Merimbula Transport Study – CBD Landscape Masterplan Assessment

The Merimbula Transport Study identifies a number of recommendations to improve Movement and Place outcomes for the town, considering the needs of all transport users, now and in the future. Some of the recommendations however are not in alignment with the CBD Landscape Masterplan. This document outlines any alignment and conflicts, and describes how the CBD Landscape Masterplan may be amended to better align with the Transport Study outcomes.

2.5.3 Main Street / Market Street Precinct

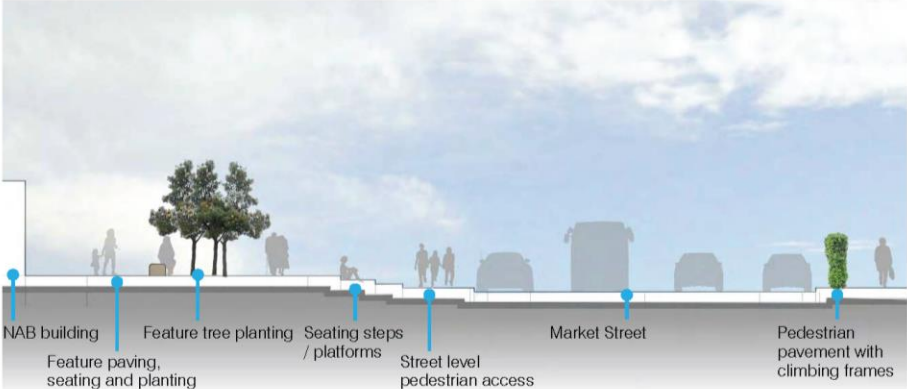
ID	Merimbula CBD Masterplan Recommendations	Alignment with Merimbula Transport Study (TS) Report Recommendations	Recommended updates to Merimbula CBD Masterplan (if recommendation conflicts with the TS report)
1	Provide feature trees at focal point and highlight entry to Market Street.	Consistent with Recommendation #P6.	-
2	Improve vehicle and pedestrian safety at intersection through installation of traffic signals at this intersection.	Consistent with Recommendation #R3.	-
3	Extend kerbs and pavement to narrow crossing distance and improve pedestrian safety.	Consistent with Recommendation #R3 and supports Recommendation #P12.	-
4	Provide garden beds, trees and furniture to extended pavement.	Consistent with Recommendation #P6 and contributes to enhanced place-making.	-
5	Provide street planting in climber on frame for improved visual and pedestrian amenity.	No conflict with the TS Recommendations.	-

6	Retain existing brick paving. Work with shop landlords and tenants to remove steps to shop fronts and provide internal ramp access.	Supports Recommendation #P7. No conflicts with TS Recommendations.	-
7	Retain existing parallel parking arrangements.	Conflict with Recommendation #P9.	Recommended to incorporate #P9 ie “Increase verge space and provide alfresco dining opportunities on Market Street between Beach Street and Main Street.

2.5.4 Merimbula Drive / Market Street Precinct

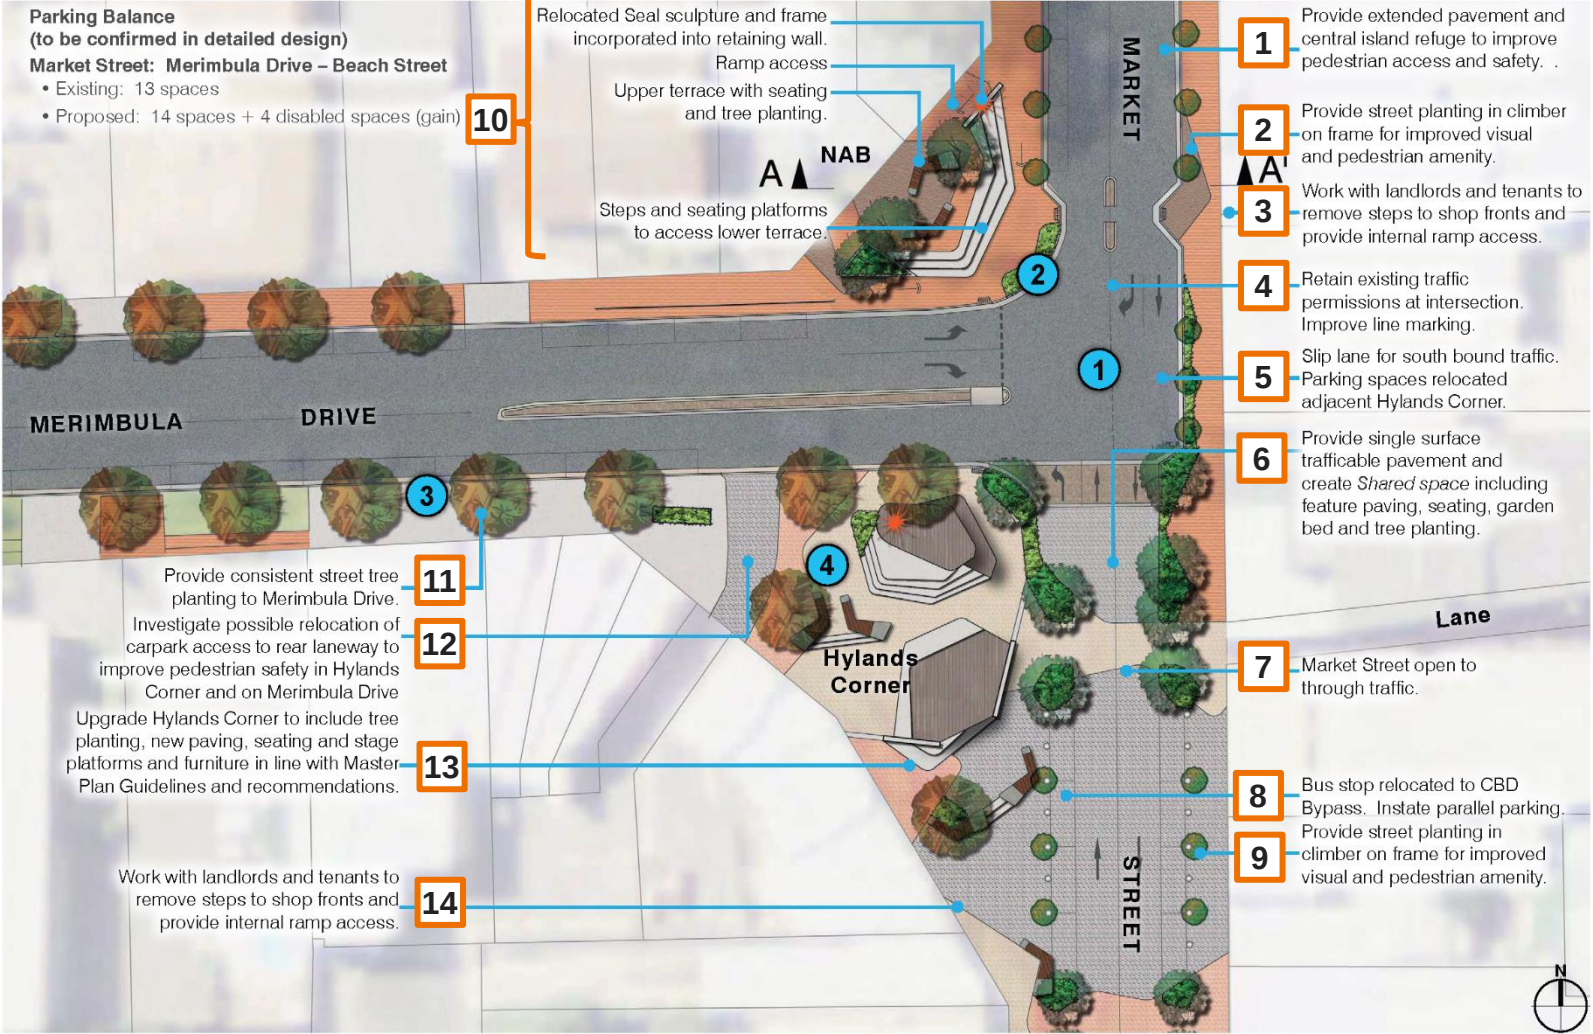
ID	Merimbula CBD Masterplan Recommendations	Alignment with Merimbula Transport Study (TS) Report Recommendations	Recommended updates to Merimbula CBD Masterplan (if recommendation conflicts with the TS report)
1	Provide extended pavement and central island refuge to improve pedestrian access and safety.	TS report proposes the provision of Disability Discrimination Act compliant wombat crossing as part of Recommendation #A3. Supports Recommendation #P12.	Incorporate Recommendation #A3 by providing a raised wombat crossing at this location. Wombat crossing provides better pedestrian priority than refuge crossing.
2	Provide street planting in climber on frame for improved visual and pedestrian amenity.	No conflict with the TS Recommendations.	-
3	Work with landlords and tenants to remove steps to shop fronts and provide internal ramp access.	Supports Recommendation #P7.	-
4	Retain existing traffic permissions at intersection. Improve line marking.	Not in alignment with Recommendation #P1 and Transformative Idea #1 which proposes one-way southbound vehicular traffic flow on Market Street between Merimbula Drive and Palmer Lane.	Incorporate the proposed vehicle movement configuration option as part of Transformative Idea #2 and Recommendation #P1 to create one-way southbound vehicular traffic flow on Market Street between Merimbula Drive and Palmer Lane.

5	Slip lane for south bound traffic. Parking spaces relocated adjacent Hylands Corner.	Not part of the TS report recommendations; no conflict with the TS report recommendations, however the proposed parking spaces relocated adjacent to Hylands Corner should be prioritised for those who need it most such as people with mobility issues and those with short term drop-off and pick-up needs as noted in Section 2.5 of the TS report.	-
6	Provide single surface trafficable pavement and create shared space including feature paving, seating, garden bed and tree planting.	Not in alignment with Recommendation #A2 (30km/hr slow speed zone).	Suggest to remove shared space on Market Street because of location of southbound bus route which may cause interactions with pedestrians. Maintain slow speed zone of 30km/hr in this location.
7	Market Street open to through traffic.	Not in alignment with Recommendation #P1 and Transformative Idea #2 which propose one way southbound vehicular traffic flow on Market Street between Merimbula Drive and Palmer Lane.	Incorporate the proposed vehicle movement configuration option as part of Transformative Idea #2 and Recommendation #P1 to create one-way southbound vehicular traffic flow on Market Street between Merimbula Drive and Palmer Lane.

8	Bus stop relocated to CBD Bypass. Instate parallel parking.	The relocation of bus stop to CBD Bypass supports the re-routing of 890 and 891 northbound buses via Merimbula Drive as part of Transformative Idea #2 and Recommendation #P1 (TS report). The instatement of parallel parking at this location might potentially conflict with Recommendation #P12; it should be noted that Section 2.5 of the TS report states that CBD parking is to be prioritised for those who need it most such as people with mobility issues and those with short term drop-off and pick-up needs.	Consider Recommendation #P12 (TS report) in terms of constricting road widths to provide either more space for people or disabled parking.

ID	Merimbula CBD Masterplan Recommendations	Alignment with Merimbula Transport Study (TS) Report Recommendations	Recommended updates to Merimbula CBD Masterplan (if recommendation conflicts with the TS report)
9	Provide street planting in climber on frame for improved visual and pedestrian amenity.	No conflict with the TS Recommendations.	-
10	Upper terrace with seating and tree planting. Provide ramp and direct step access to lower terrace, street and aligned pedestrian crossing location. Steps and seating platforms to access lower terrace. Relocated Seal sculpture and frame incorporated into retaining wall.	The upgrade of NAB Corner is not part of the TS report recommendations however does not conflict with the TS report recommendations. The inclusion of proposed ramp access is in line with Recommendation #P7.	-
11	Provide consistent street tree planting to Merimbula Drive.	Consistent with Recommendation #P6.	-

12	Investigate possible relocation of carpark access to rear laneway to improve pedestrian safety in Hylands Corner and on Merimbula Drive.	No conflict with the TS report recommendations.	-
13	Upgrade Hylands Corner to include tree planting, new paving, seating and stage platforms and furniture in line with Master Plan Guidelines and recommendations.	Consistent with Recommendation #P10.	-
14	Work with landlords and tenants to remove steps to shop fronts and provide internal ramp access.	Supports Recommendation #P7.	-

2.5.5 Market Street / Beach Street Precinct

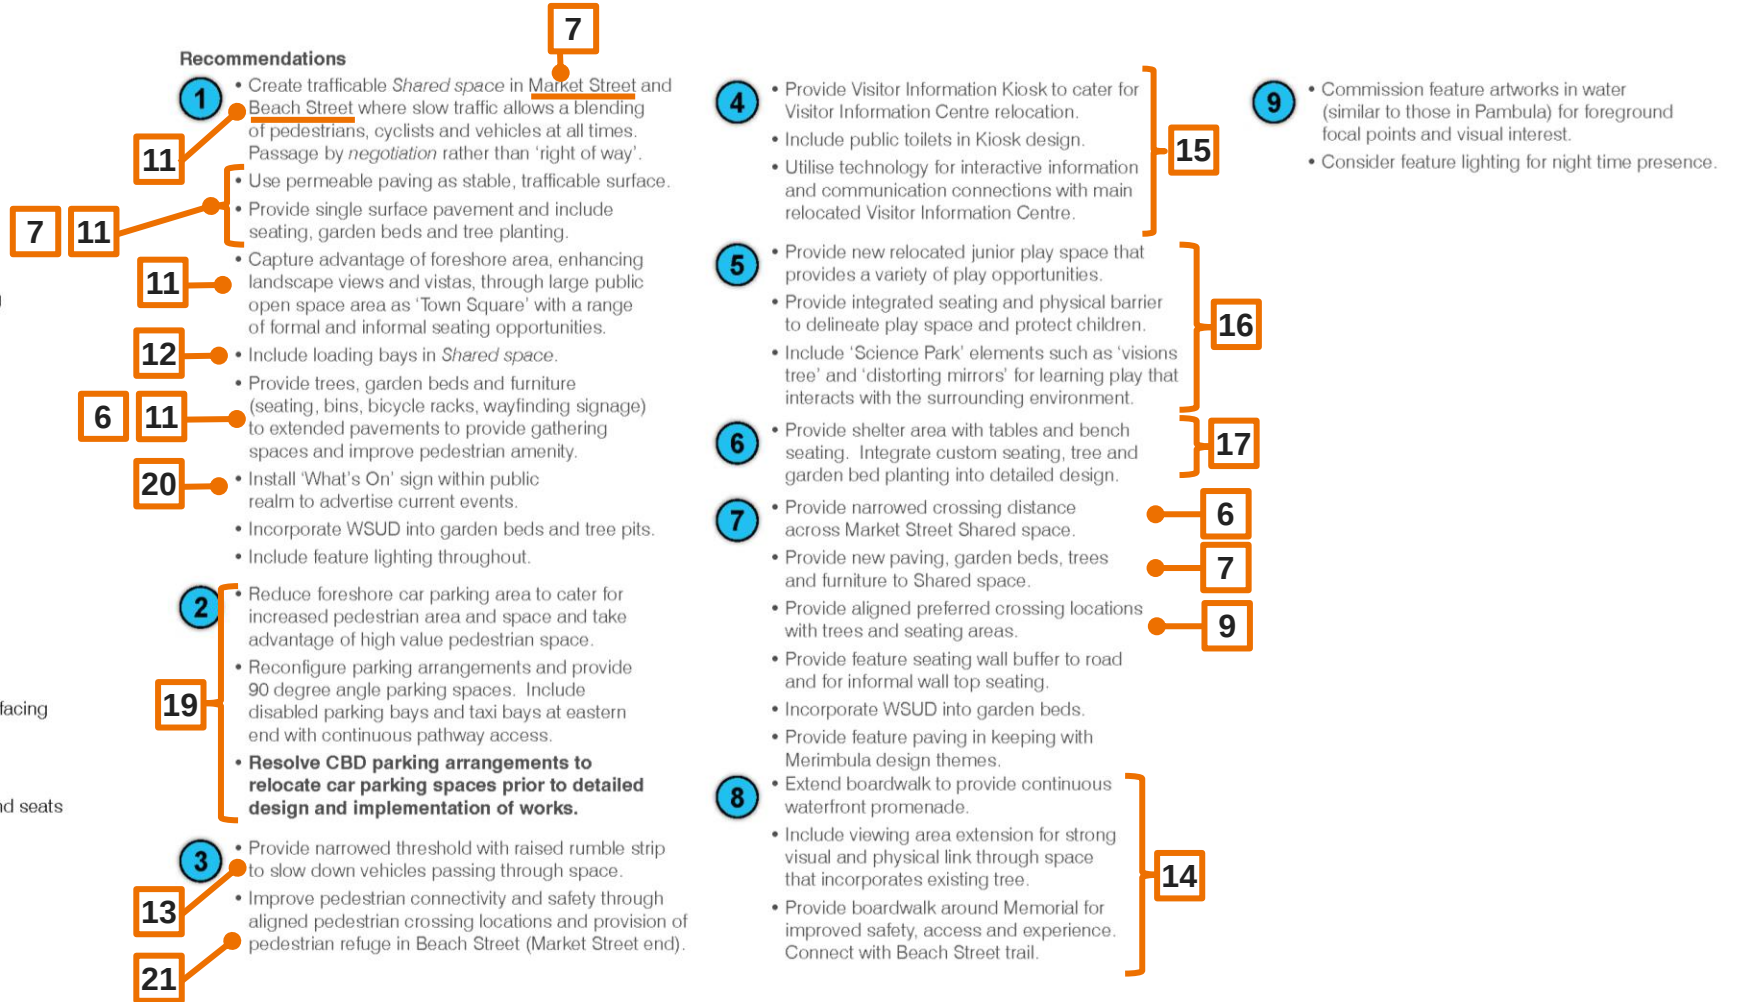
ID	Merimbula CBD Masterplan Recommendations	Alignment with Merimbula Transport Study (TS) Report Recommendations	Recommended updates to Merimbula CBD Masterplan (if recommendation conflicts with the TS report)
1	Provide street planting in climber on frame for improved visual and pedestrian amenity.	No conflict with the TS report recommendations.	-
2	Retain seating area, raised garden bed and planting.	No conflict with the TS report recommendations.	-
3	Market Street open to through traffic.	Not in alignment with Recommendation #P1 and Transformative Idea #2 which propose one way southbound vehicular traffic flow on Market Street between Merimbula Drive and Palmer Lane.	Consider the proposed vehicle movement configuration option as part of Transformative Idea #2 and Recommendation #P1 to create one-way southbound vehicular traffic flow on Market Street between Merimbula Drive and Palmer Lane.

4	Beach Street open to through traffic.	Not in alignment with Recommendation #P1 and Transformative Idea #2 which propose one way eastbound vehicular traffic flow on Beach Street.	Incorporate the proposed vehicle movement configuration option as part of Transformative Idea #2 and Recommendation #P1 to create one-way southbound vehicular traffic flow on Market Street between Merimbula Drive and Palmer Lane.
5	No right turn into Market Street from Beach Street to improve traffic flow.	Not in alignment with Recommendation #P1 and Transformative Idea #2 whereby northbound movements are not permitted at the intersection of Beach Street and Market Street.	Incorporate the proposed vehicle movement configuration option as part of Transformative Idea #2 and Recommendation #P1 to create one-way southbound vehicular traffic flow on Market Street between Merimbula Drive and Palmer Lane.
6	Extend pedestrian pavement to narrow crossing distance. Provide new paving, garden beds, trees and furniture to extended pavement.	Supports Recommendation #P12.	-

7	Provide single surface trafficable pavement and create shared space including feature paving, seating, garden bed and tree planting.	Not in alignment with Recommendation #A2 (30km/hr slow speed zone).	Suggest to remove shared space on Market Street because of location of southbound bus route which may cause interactions with pedestrians. Maintain slow speed zone of 30km/hr in this location.
8	Work with shop landlords and tenants to remove steps to shop fronts and provide internal ramp access.	Supports Recommendation #P7.	-
9	Remove existing pedestrian lights to allow for shared space. Signify preferred crossing locations with paving and tree planting.	Not in alignment with Recommendation #A5 (provide raised pedestrian crossing).	Suggest to remove shared space on Market Street because of location of southbound bus route which may cause interactions with pedestrians. Provide raised wombat crossing in this location.

10	Relocate Bus stop to CBD Bypass. Instate disabled parking bays.	Southbound bus route does not need to be re-routed to the CBD Bypass (as per Transformative Idea #2 and Recommendation #P1).	Consider retaining the bus stop for southbound bus routes at this location and provide disabled parking spaces north of the bus stop as per Recommendation #PA3.

ID	Merimbula CBD Masterplan Recommendations	Alignment with Merimbula Transport Study (TS) Report Recommendations	Recommended updates to Merimbula CBD Masterplan (if recommendation conflicts with the TS report)
11	Provide single surface trafficable pavement and create shared space including seating, garden bed and tree planting.	Consistent with Recommendation #A2; supports Recommendation #P4 and Transformative Idea #3. Traffic movements on Beach Street not consistent with #P1 and Transformative Idea #2.	Traffic movement to be modified to be consistent with Transformative Idea #2 ie one-way eastbound movement on Beach Street. Retain shared space on Beach Street. Shared zone on Beach Street between Market Street and Alice Street to be 10km/hr speed limit.
12	Provision of loading bays.	No conflict with the TS report recommendations.	-
13	Narrowed threshold with raised rumble strip to slow down vehicles passing through space.	No conflict with the TS report recommendations. Supports Recommendation #A2.	-

14	Extend boardwalk to provide continuous waterfront promenade. Provide boardwalk around Memorial for improved safety, access and experience. Connect with Beach Street trail.	Supports the Transformative Idea #1.	-
15	Provide Visitor Information Kiosk to cater for Visitor Information Centre relocation. Include public toilets in Kiosk design.	Consistent with Recommendation #P4 and Transformative Idea #3; Supports Recommendation #P2.	-
16	Provide new relocated junior play space that provides a variety of play opportunities. Provide integrated seating and physical barrier to delineate play space and protect children.	Consistent with Recommendation #P4 and Transformative Idea #3.	-
17	Provide shelter area with tables and bench seating.	Consistent with Recommendation #P4 and Transformative Idea #3.	-
18	Enhance waterfront amenity with signature tree planting.	Consistent with Recommendation #P4 and Recommendation #P6.	-

19	Reconfigure parking arrangements to allow for public open space in high value foreshore land. Provide 90 degree angle parking spaces. Include disabled parking bays at eastern end and continuous pathway access.	Proposed parking configuration is not in alignment with Recommendation #P4 and Transformative Idea #3.	Incorporate proposed parking arrangements as per Recommendation #P4 and Transformative Idea #3 ie 45 degree angled parking on northern side of Beach Street.
20	Install 'What's On' sign within public realm to advertise current events.	Supports Recommendation #P2.	-
21	Improve pedestrian connectivity and safety through aligned pedestrian crossing locations and provision of pedestrian refuge in Beach Street (Market Street end).	Aligns with Recommendation #P1 and Transformative Idea #2 – propose one-way eastbound vehicular traffic flow on Beach Street.	Recommend not to have a pedestrian refuge within a shared zone, because this treatment gives priority to vehicles. Shared zone gateway treatments are recommended, pedestrians may cross anywhere within a shared zone.

2.5.6 Market Street / Monaro Street Precinct

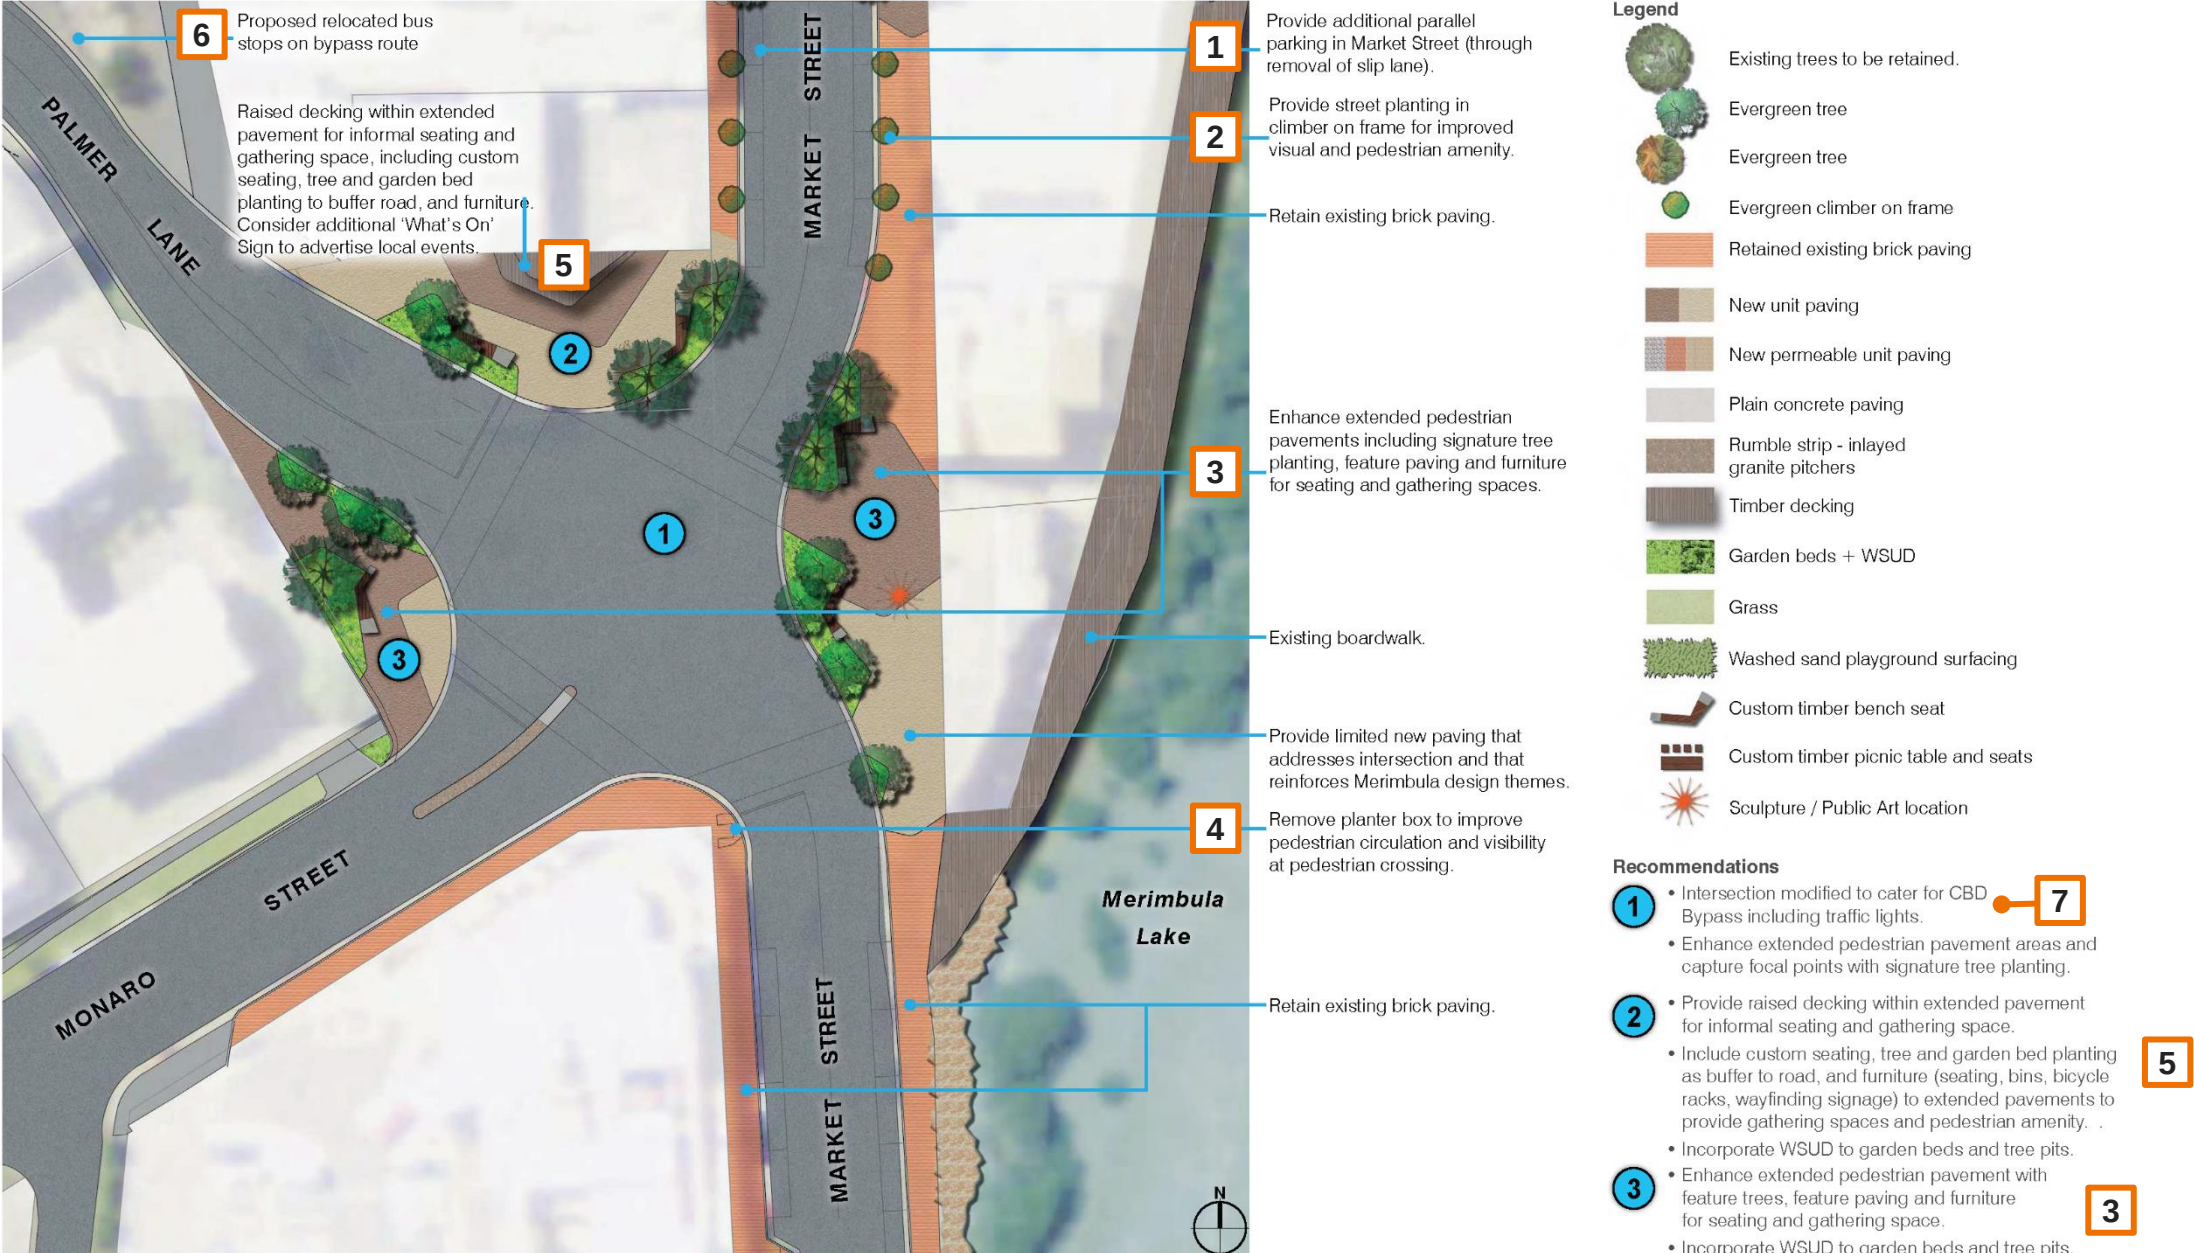
ID	Merimbula CBD Masterplan Recommendations	Alignment with Merimbula Transport Study (TS) Report Recommendations	Recommended updates to Merimbula CBD Masterplan (if recommendation conflicts with the TS report)
1	Provide additional parallel parking in Market Street (through removal of slip lane).	Not part of the TS report recommendations; it should be noted that Section 2.5 of the TS report states that CBD parking is to be prioritised for those who need it most such as people with mobility issues and those with short term drop-off and pick-up needs Potential conflict with Recommendation #P12.	Incorporate recommendation #P12 in terms of constricting road widths to provide either more space for people or disabled parking.
2	Provide street planting in climber on frame for improved visual and pedestrian amenity.	No conflict with the TS report recommendations.	-
3	Enhance extended pedestrian pavements including signature tree planting, feature paving and furniture for seating and gathering spaces.	Supports Recommendation #P12.	-

4	Remove planter box to improve pedestrian circulation and visibility at pedestrian crossing.	Supports Recommendation #R3.	-
5	Raised decking within extended pavement for informal seating and gathering space, including custom seating, tree and garden bed planting to buffer road, and furniture. Consider additional 'What's On' Sign to advertise local events.	Supports Recommendation #P12 and consistent with #P2.	-
6	Proposed relocated bus stops on bypass route.	Bus stop(s) on southern side of Park Street: supports the re-routing of 890 and 891 northbound buses via Merimbula Drive as part of Transformative Idea #2 and Recommendation #P1. Bus stop(s) on northern side of Park Street: existing southbound regular public bus routes do not travel through Park Street and these bus routes do not need to be re-routed as part of Transformative Idea #2 and Recommendation #P1.	Consider the instatement of bus stops on southern side of Park Street only (in the case that only the northbound buses are re-routed).

7	Intersection modified to cater for CBD Bypass including traffic lights.	Consistent with Recommendation #R2.	-
